ADDENDUM NO. 1

DATE: July 1, 2020

MERCED COLLEGE HEALTH CENTER PROJECT
MCCD BID NO. 2020-03

DARDEN PROJECT NO. 1954
DSA File Nos. 24-C1
DSA APPL. NO. 02-118108

A/A601

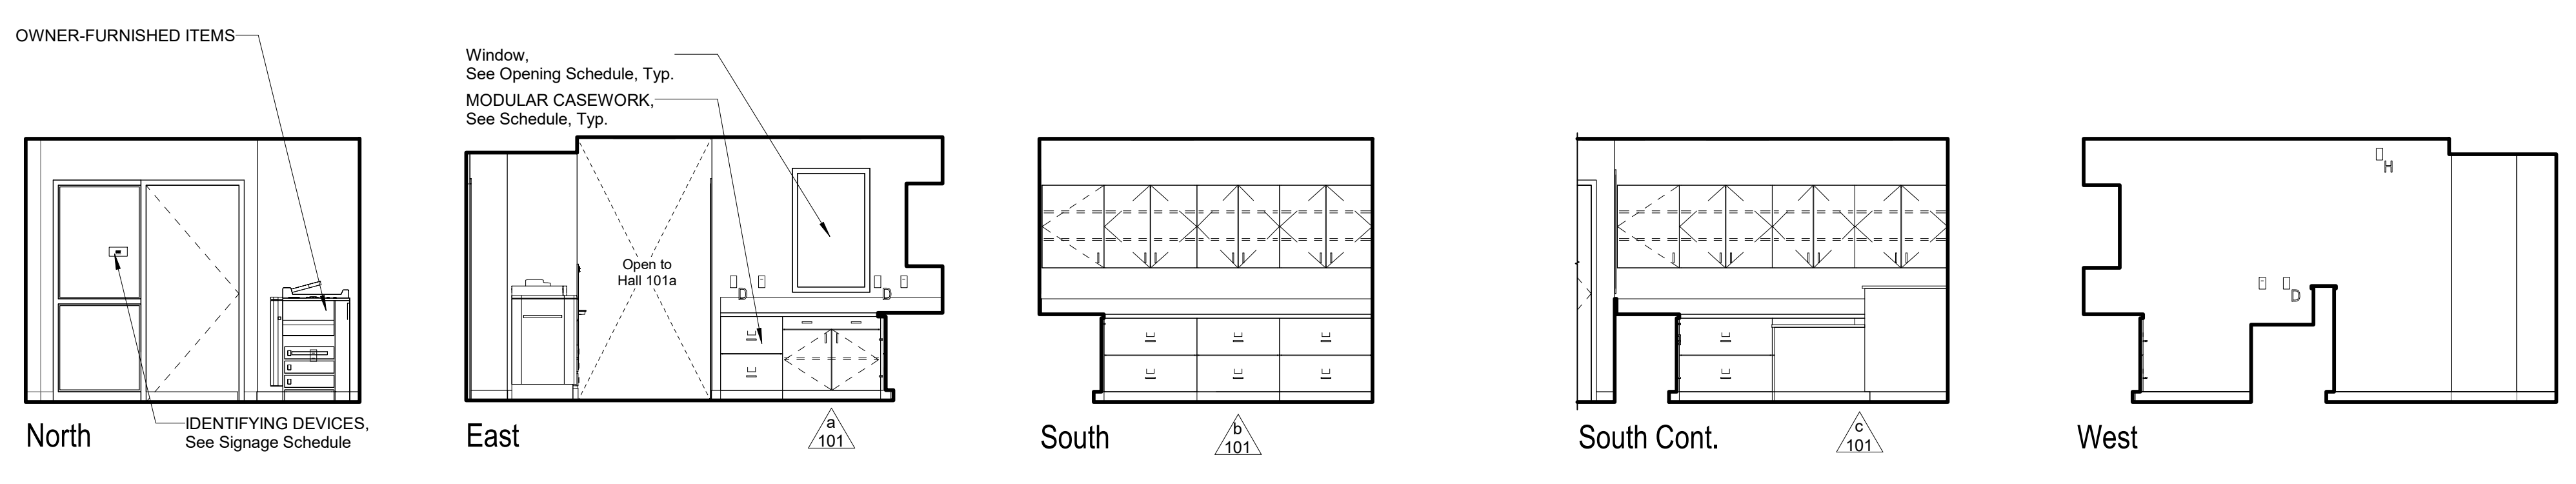
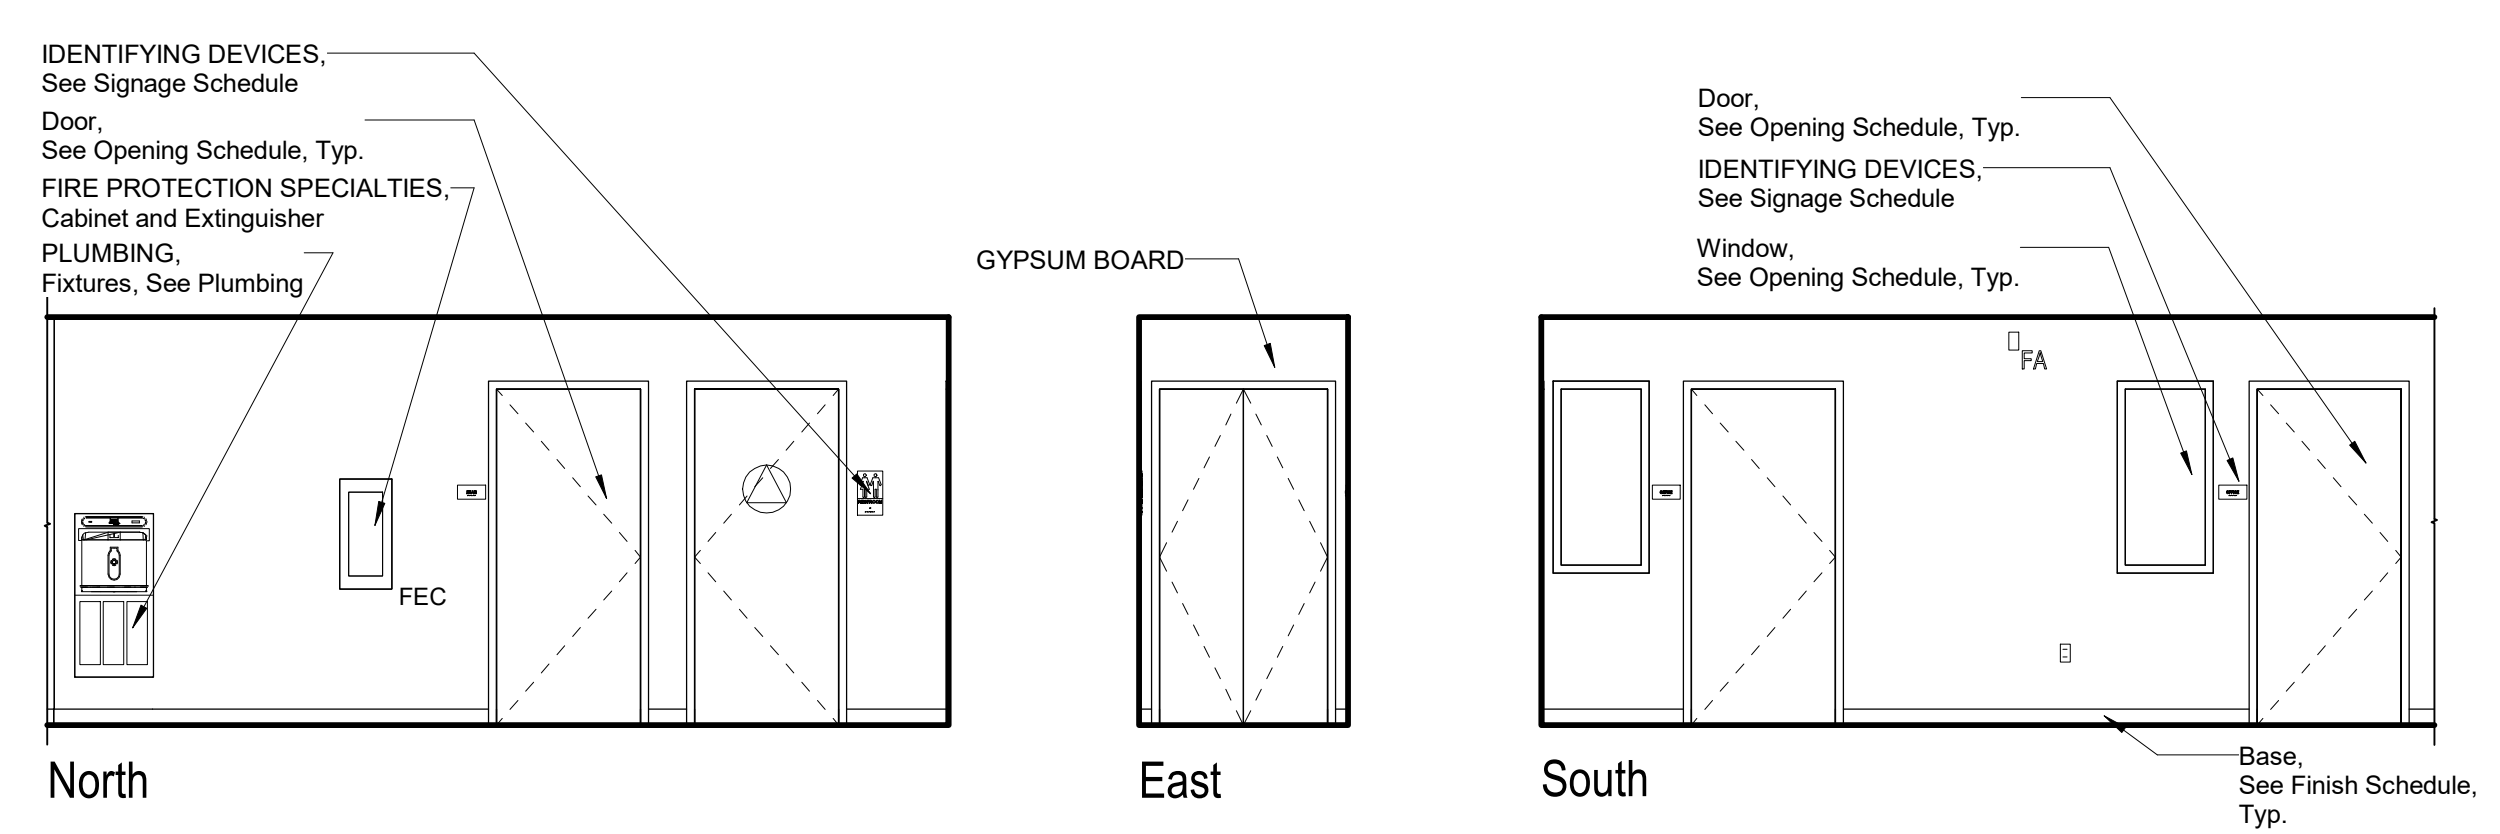
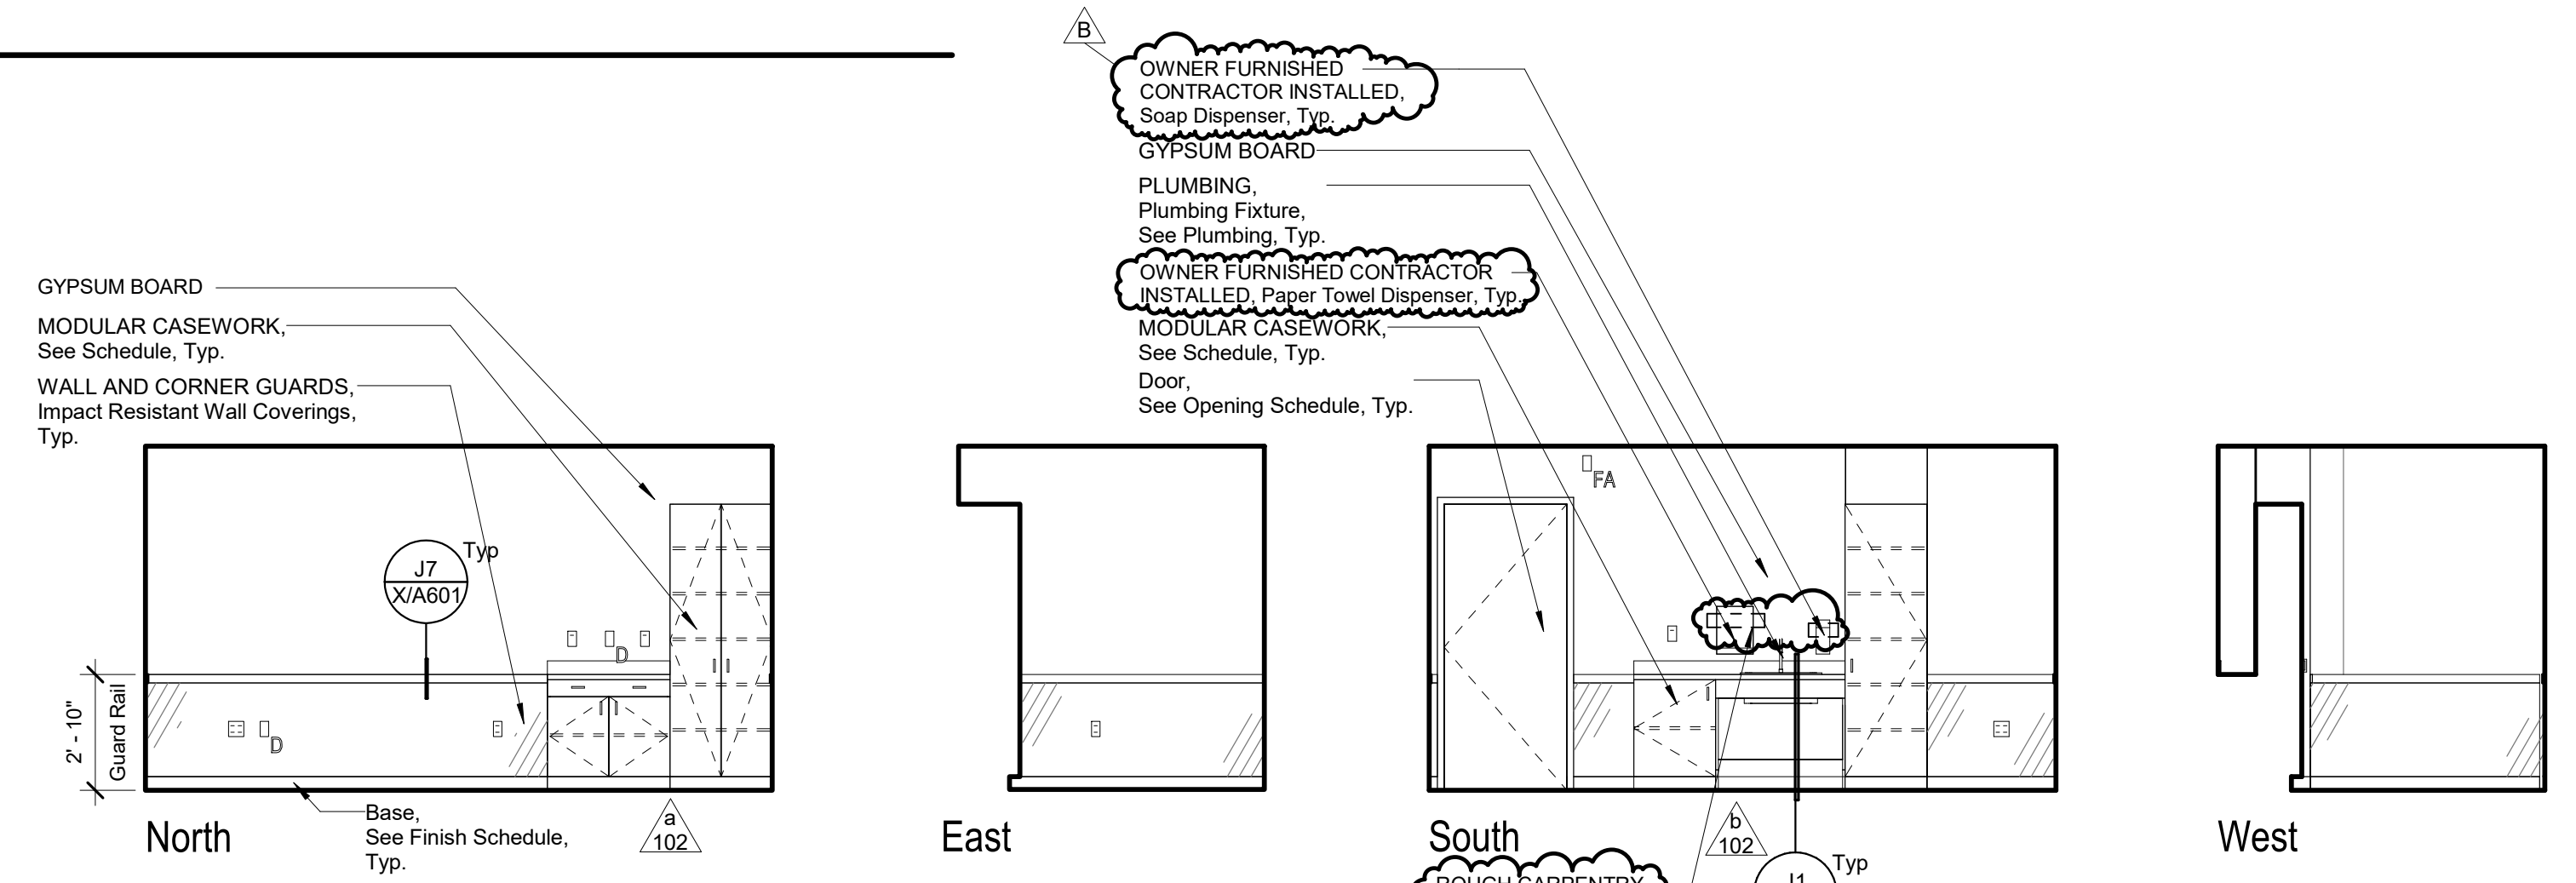
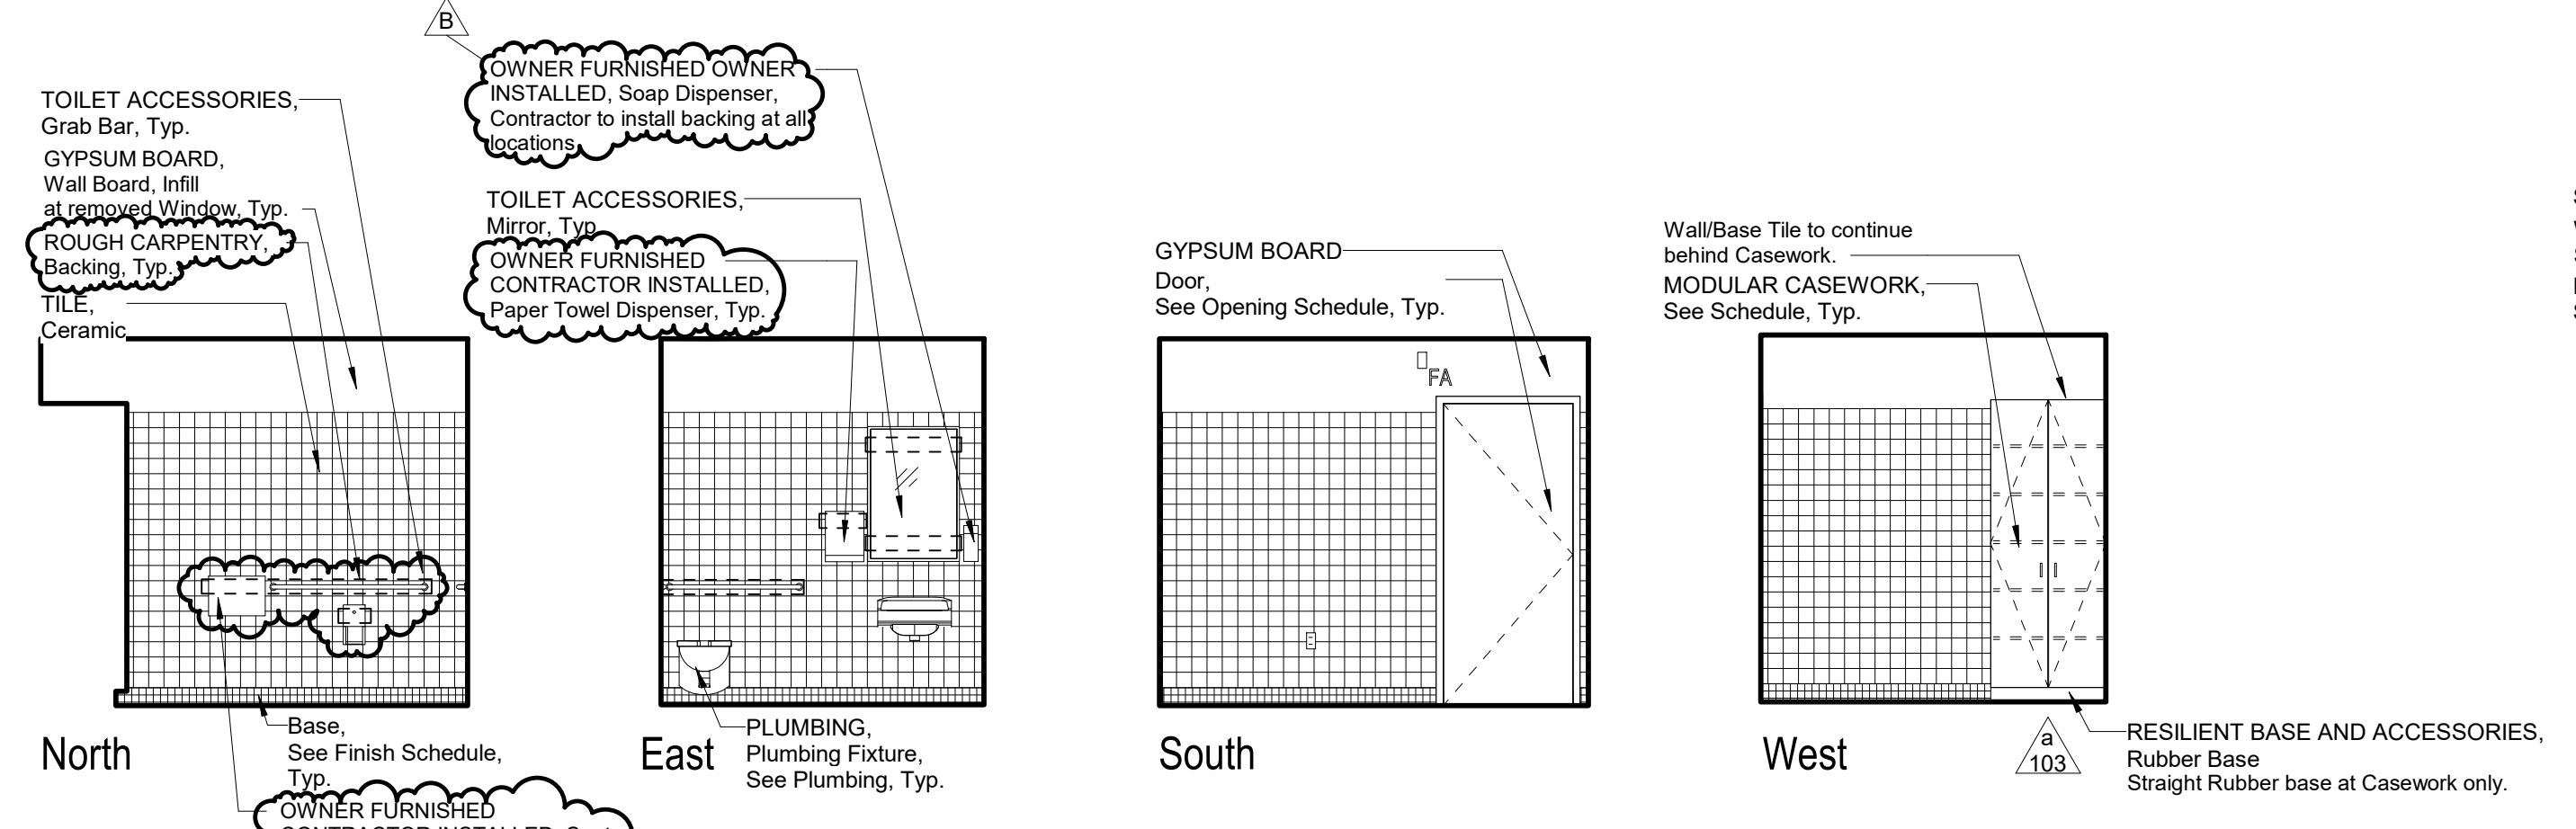
- AD1-A03 Refer to Sheet A/A601, INTERIOR ELEVATIONS:**
1. Remove and replace sheet A/A601, INTERIOR ELEVATIONS with the attached AD1-AX01.
